## Groundwater Application Review Summary Form

Application # G- 18702

**PUBLIC INTEREST REVIEW FOR GROUNDWATER APPLICATIONS**

TO: Water Rights Section Date 12/19/2018  
 FROM: Groundwater Section Travis Brown, Dennis Orlowski  
Reviewer's Name  
 SUBJECT: Application G- 18702 Supersedes review of \_\_\_\_\_  
Date of Review(s)

Water-Level Trends in Nearby Wells

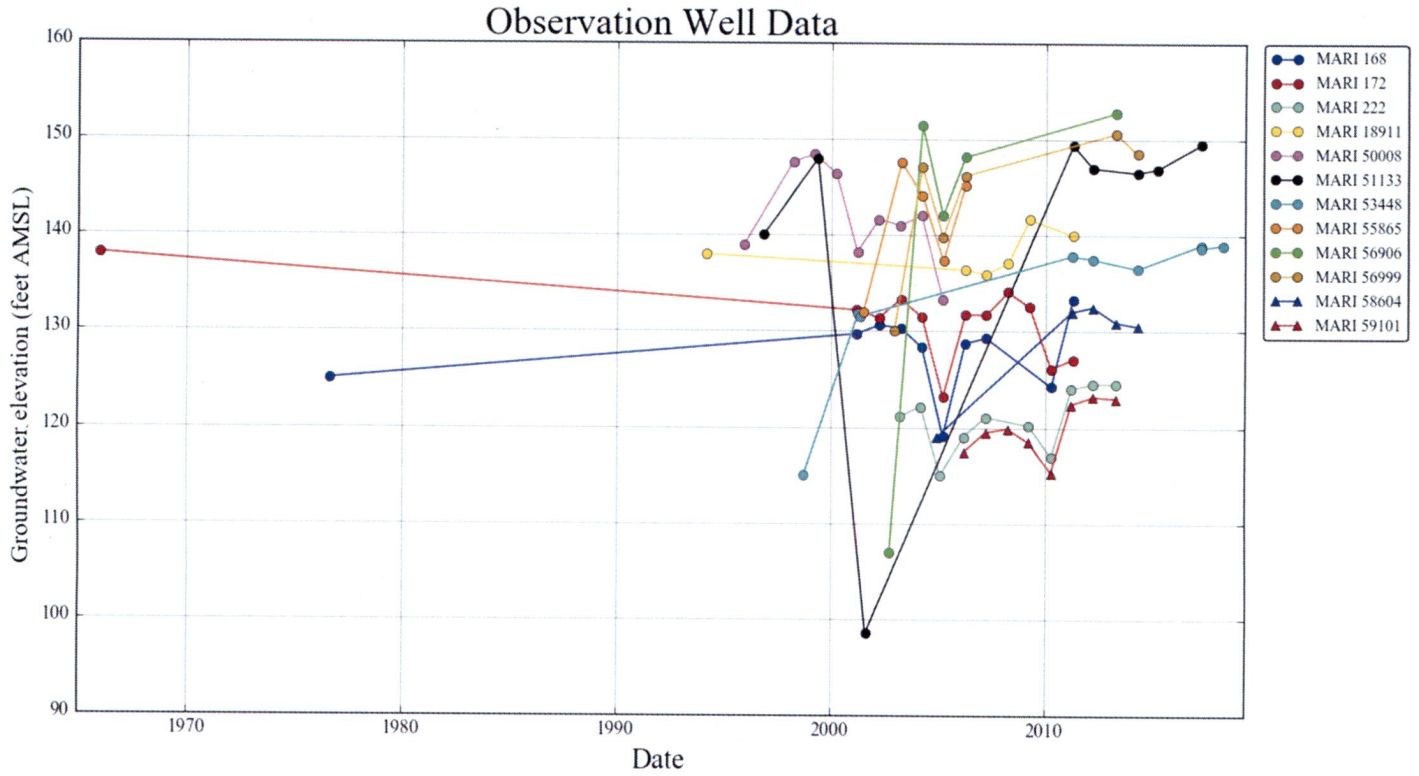
Water levels in nearby wells show no obvious declines in recent years, and in several cases appear to be slightly increasing within the past decade (see attached hydrographs).
